Board of Zoning and Planning

Staff Report

January 25, 2024

The proposed work and the setback distances to the proposed work.

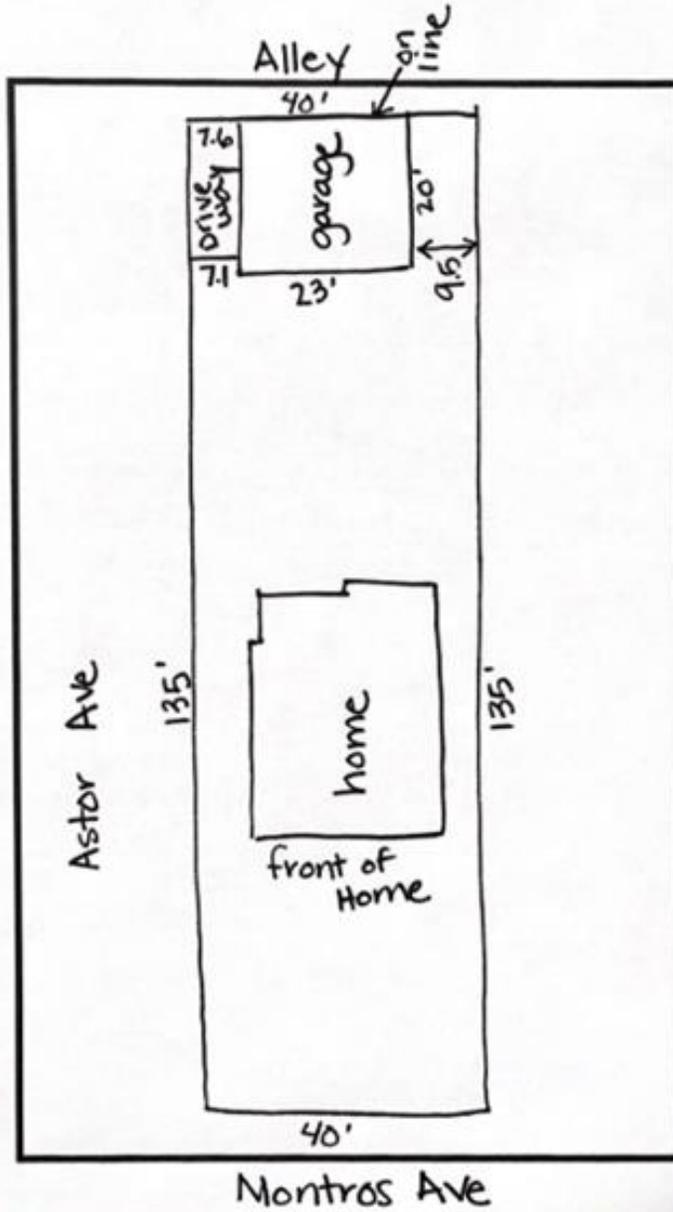
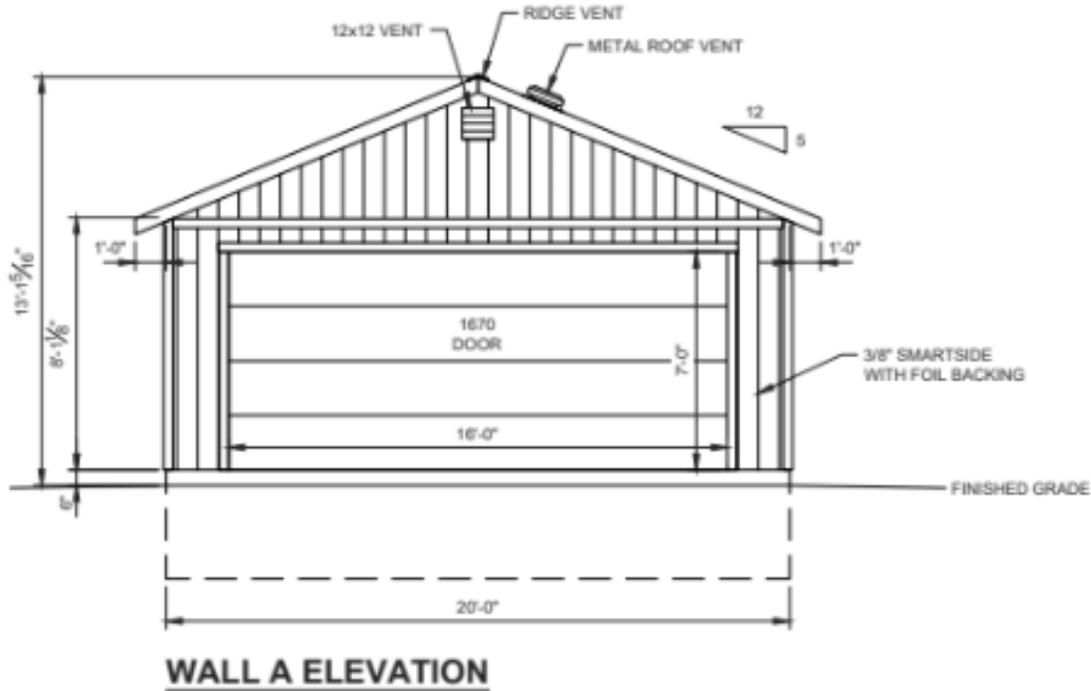
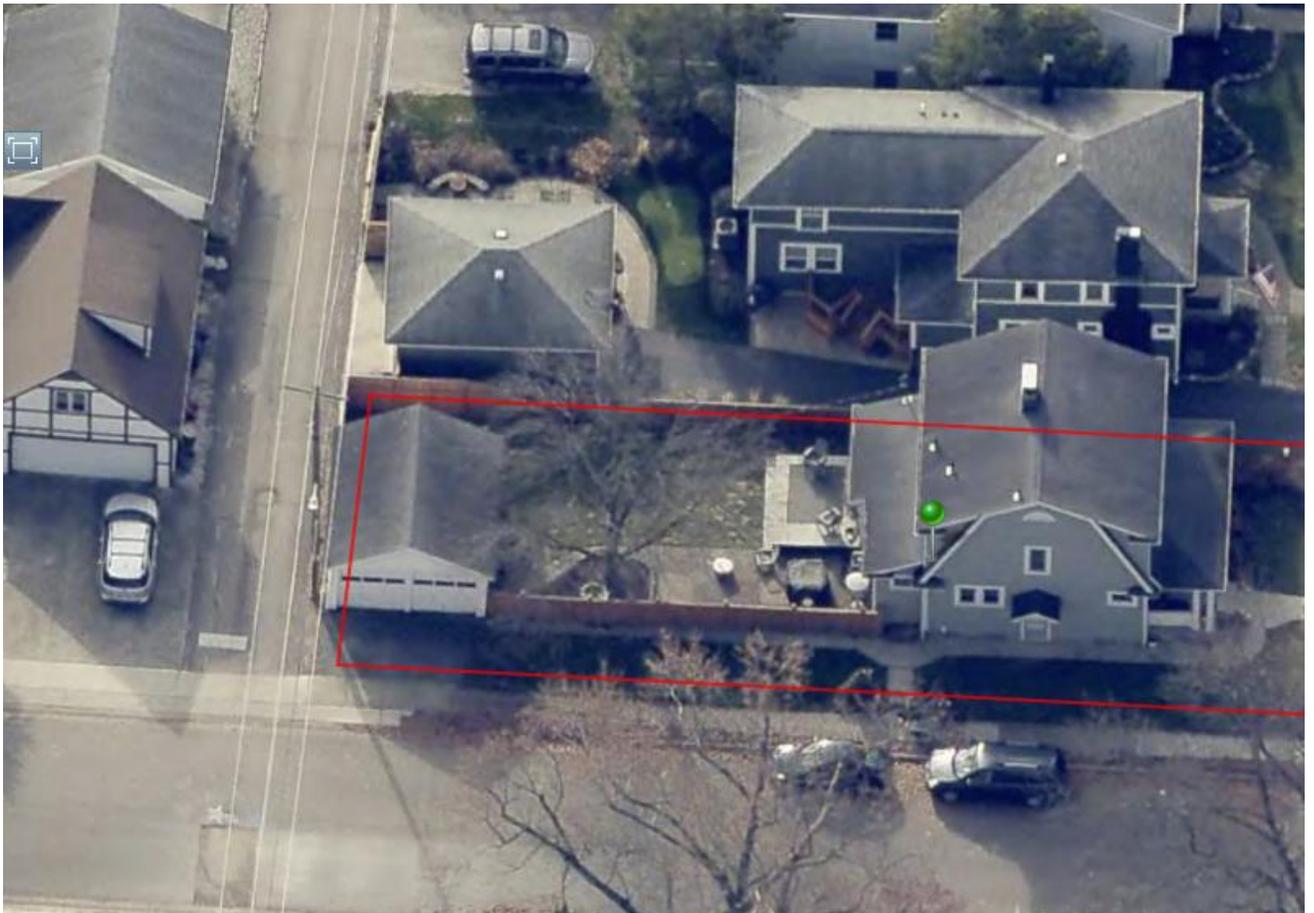
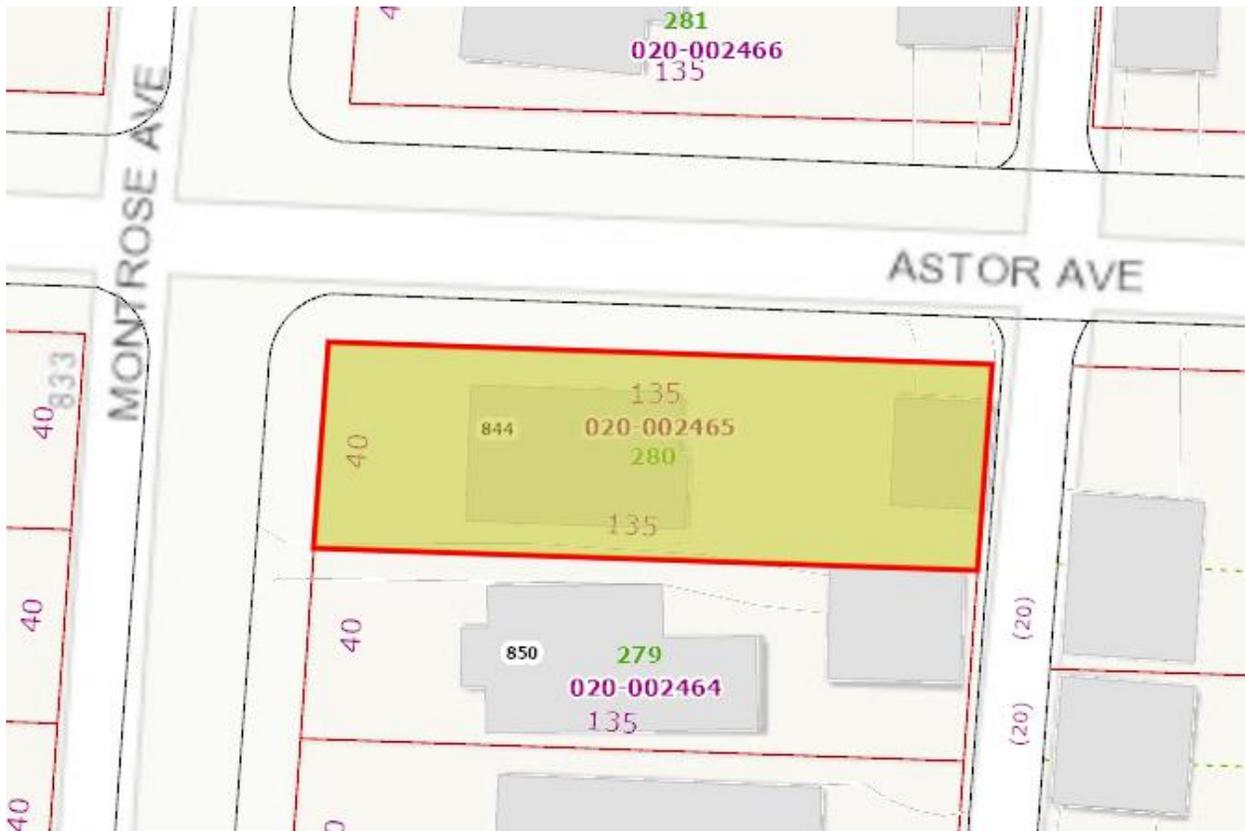
The existing garage is currently located on the east (rear) property line and the eaves actually overhang into the alley. This might be a good time to make appropriate adjustments to at least pull the garage far enough away from the property line to prevent the eaves from overhanging into the alley. Typically, a property line is approximately 6" off of the alley pavement. The

survey submitted for the existing garage shows it to be 1' over the line; which places it 6" into the alley. It only makes sense to correct the location at this point, as the proposed eaves are 1' and would place it 6" into the alley.

The fact that the garage is not at the corner of the property and there is a utility pole on that side of the alley, may be the only factor that prevented any damage to the structure. My only concern is that if the garage is moved away from the alley that it not be enough to impact the existing tree in the rear yard.

SITE PLAN 1" = 20'-0"

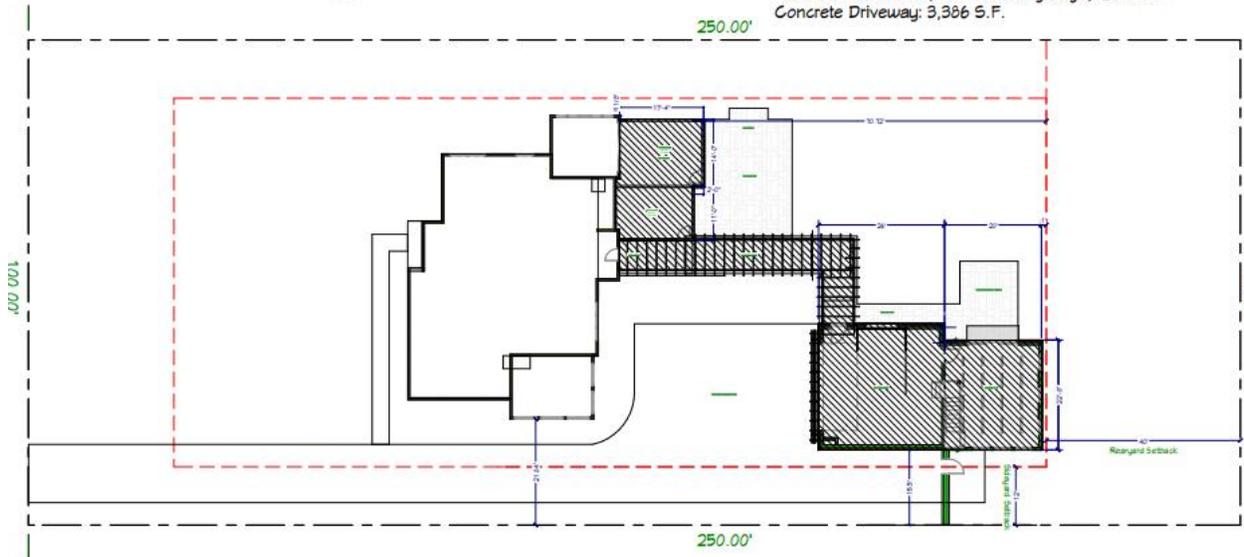
The proposed garage is being called "attached" and submitted for design review as an addition to the principal structure.

By calling the garage an "addition", it can exceed the size limit for accessory structure (which it does) and simply meet the 25% building lot coverage limit and setback requirements for the R-3 Zoning District.

In accordance Bexley Code Section 1230.02, which defines "accessory use or structure", it would require a variance to exceed the 936sq' and exceed 35% of the principal structure, based on the fact that parking structures are accessory structures or uses or where they are the principal structure or use or where they are an "integral" part of the principal structure or use.

Staff would define the garage as an "accessory structure"; being it is separate from the massing of the principal structure, making it less of an integral part of the principal structure.
